IDAP REPORT

Property:	118-120 Homebush Road Strathfield Lot A in DP 382199 DA2021.41
Proposal:	Demolition of existing structures and construction of two (2) storey dwelling with basement level, front fencing and in-ground swimming pool.
Applicant:	A Mulder
Owner:	J M Chen and Z X Chen
Date of lodgement:	22 February 2021
Notification period:	5 March 2021 to 19 March 2021
Submissions received:	One (1) submission
Assessment officer:	M Rivera
Estimated cost of works:	\$1,264,314.00
Zoning:	R2 – Low Density Residential - SLEP 2012
Heritage:	No
Flood affected:	No
RECOMMENDATION OF OFFICER:	APPROVAL

Figure 2. Site Plan

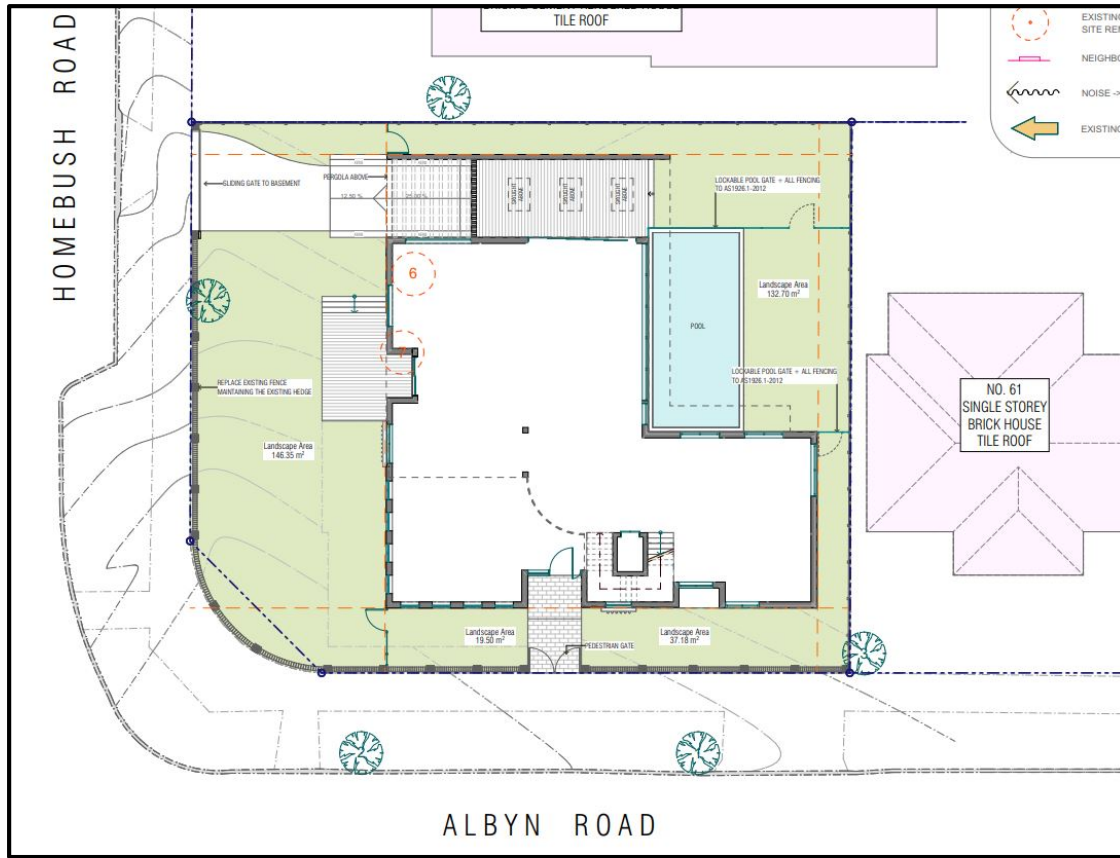
The rear setback of the new dwelling house is proposed to be 1.5m, which represents a variation of 4.5m (75%) to the minimum rear setback control under the DCP. The unique corner context of the site and current configuration of the existing dwelling house and adjoining neighbours are identified as key considerations when assessing the merits of this variation. On balance, the variation is considered reasonable as the development relates appropriately to other built forms and respective private open spaces. The variation is also similar to the setback and separation of the existing dwelling house – reflecting the allocation of the north-eastern corner of the site as the primary private open space of the residence. This outcome

Figure 12. Proposed fence along Homebush Road

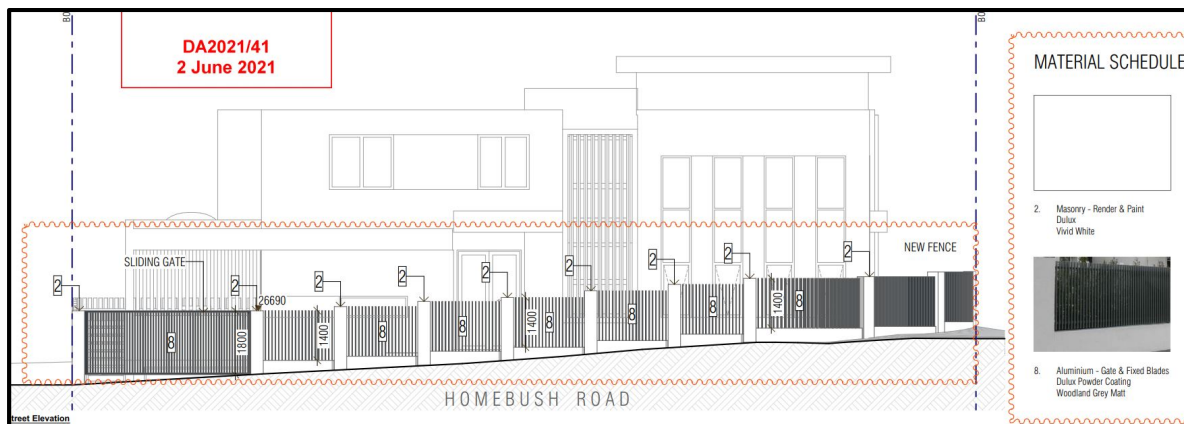
The design of the proposed front fencing, which comprises masonry piers and metal palisade screening, demonstrates general compliance with the relevant controls for front fencing (refer to Figures 12 and 13). It is noted however, that the proposed gates at the driveway leading to the basement and accessed from Homebush Road will have a height of 1.8m. This exceedance is considered acceptable and supportable given that the gates are visually permeable and contain no solid opaque components. The majority of all fencing along Albyn Road and Homebush Road is 1.2-1.4m tall and easily comply with the maximum fencing height control.

Figure 14. Basement portion extended beyond ground floor footprint

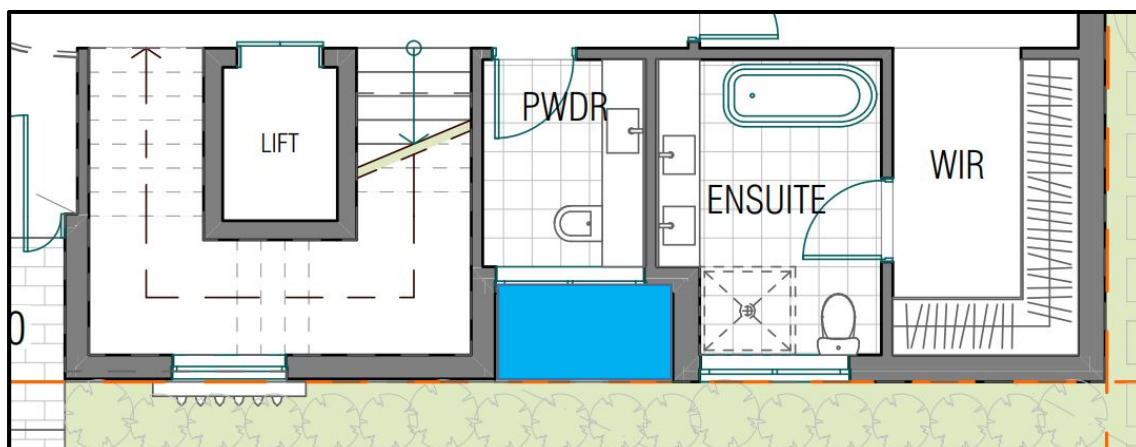
A nominal portion of basement on the southern side of the house extends beyond the ground floor footprint (refer to Figure 14). A condition will be imposed to delete this completely and to ensure that the wall of the basement follows the recessed wall of the upper levels above.

Width of driveway	The width of the driveway crossing must be reduced to 3m to achieve a maximum allowed width of 3m at the property boundary. Any front fence or gate opening adjustments required as a result of this reduction must be illustrated on the plans lodged with the application for the Construction Certificate.
Basement level – portion deleted.	<p>The portion of basement that is situated beneath the portion (shaded in blue, in the figure below) must be deleted completely. The wall of the basement is to follow the recessed wall of the upper levels above.</p>
